KIA MOTORS

MODEL
Soul (AM)

NUMBER
053

SUBJECT: SERVICE ACTION: REAR WIPER SQUEAL NOISE REPAIR (SA026)

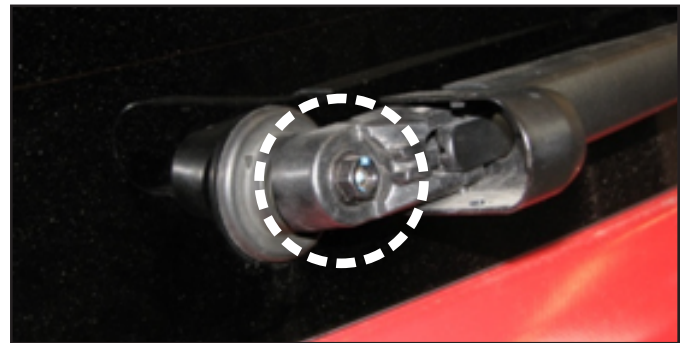
1. Mark wiper arm location using a paint pen, and then remove the rear wiper arm assembly to gain access to the rubber grommet.

Lift rear wiper retaining nut cover to gain access to retaining nut.

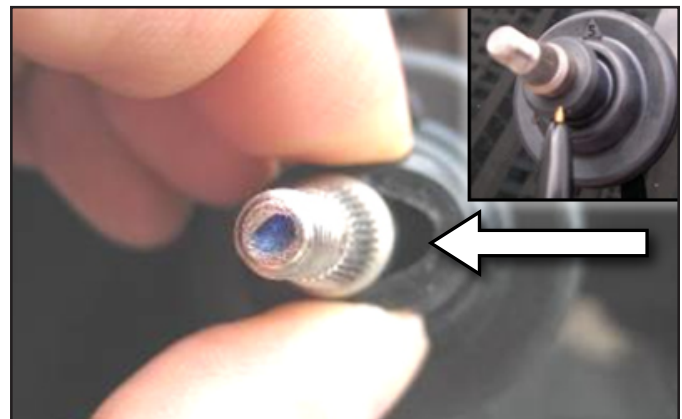
2. Press the top of the grommet with two fingers to make the opening bigger as shown in the photo, and then apply Multemp AC-J automotive grease/3M Silicone Paste to the inner surface area of the grommet through the opening as indicated by the arrow.

Use Multemp AC-J automotive grease or 3M Silicone Paste P/N 08946 (Stock no. 60980017481. UPC 0-51135-08946-0.
